Havant Thicket Reservoir

Environmental Statement Addendum

Reference: HTR-RHD-ZZ-ZZ-RP-Z-0001

Figure 2-1: Embankment size and alignment change from approved alignment to proposed

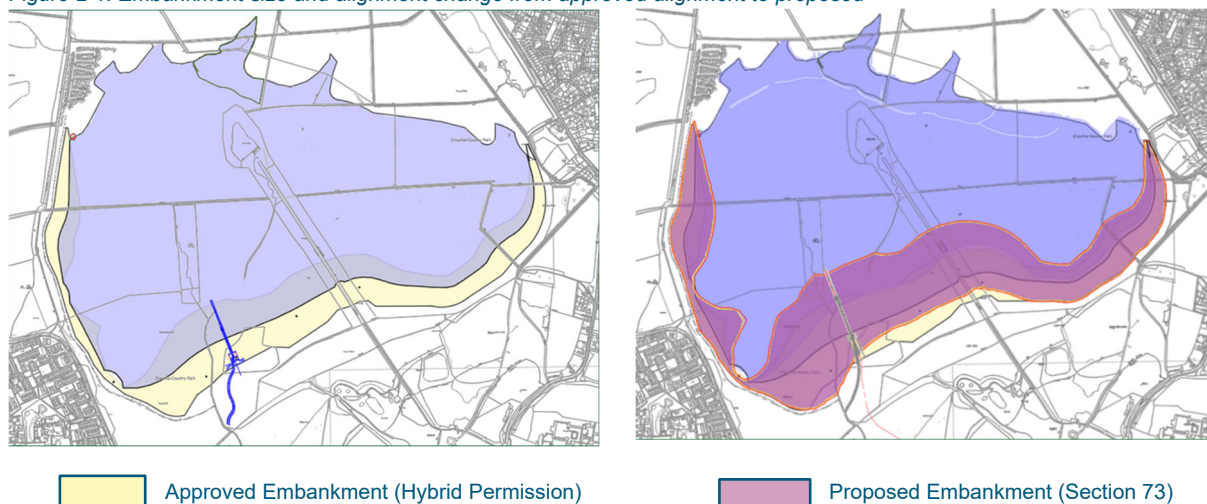
- 2.2.6 The following changes to the size and alignment of the main reservoir embankment are proposed in this S73 application:
- To facilitate construction of the embankment the southern toe of the main embankment is proposed to be realigned, as shown on drawing HTR-COF-EM-RE-DR-GE-4002 Main Embankment Proposed Site Layout, which includes:

- Minor realignment of the western embankment.
 - The slope angles of the inside and outside embankment faces have been re-designed to be shallower, with the slope reduced to between 1:8 and 1:9, as shown on drawing HTR-COF-EM-RE-DR-GE-4003 Main Embankment Cross-Sections, which results in a larger main embankment footprint that extends further north.

- As a result of the combination of the realigned embankment and the redesigned slope angles, the crest line of the embankment also moves approximately 80 m north and the overall embankment length increases by 30 m to 2,800 m in total, as shown on as shown on drawing HTR-COF-EM-RE-DR-GE-4002 Main Embankment Proposed Site Layout, including the eastern tie in of the main embankment (the point at which the embankment ties in with the existing ground level) moving up to 55-60 m to the north.

2.2.7 The changes to the size and alignment of the main reservoir embankment proposed for the S73 application are illustrated in **Figure 2-1**, which shows the approved embankment and the proposed embankment.

2.2.8 The Application Scheme Parameters (which describe the proposed changes to the Scheme, and to the Scheme Parameters which have informed the environmental assessment work as presented in the ES Addendum to the 2020 ES) set out in **Table 2-2**, include a greater range of slope angles for the main embankment varying between 1:7 to 1:9, which differs from that shown on the application drawings at 1:8 to 1:9. The greater range of slope angles has been included in the Application Scheme Parameters to allow for the opportunity to steepen the slope angles in some areas should that opportunity be possible through further engineering design and assessment work. Portsmouth Water and Future Water are not able to confirm or commit to the steeper slope angles at this time, and therefore the greater range in the Application Scheme Parameters allows that opportunity to come forward in the future, if it proves possible, alongside any necessary consents required. Steepening the slope angles would be beneficial as it would reduce the footprint of the embankment, the volume of material required and the time to construct parts of the embankment. This ES Addendum considers slope angles at both 1:8 to 1:9 and 1:7 to 1:9.

- 2.2.11 The crest line for the section of 'Embankment adjacent to Staunton Country Park' are fixed as set out in **Table 2-2** Application Scheme Parameters below and shown on the application drawing in **Figure 2-1**.

- 2.2.12 The changes to the embankment slopes and alignment have been designed to ensure a cut and fill balance and minimal net change in the reservoir volume, maintaining the minimum total capacity of 8,700 million litres.

- 2.2.13 The height of the embankment crest level of 40.5 m Above Ordnance Datum (AOD) would not change from the 2020 ES.
- 2.2.14 The elements of the main embankment that are proposed as outline and full planning permission are shown on drawing HTR-GHD-ZZ-ZZ-DR-T-0021 Planning Application Strategy Key Plan, consistent with the approach approved under the hybrid planning permission and the Phase 3 Reserved Matters Applications being submitted alongside the S73 Applications.
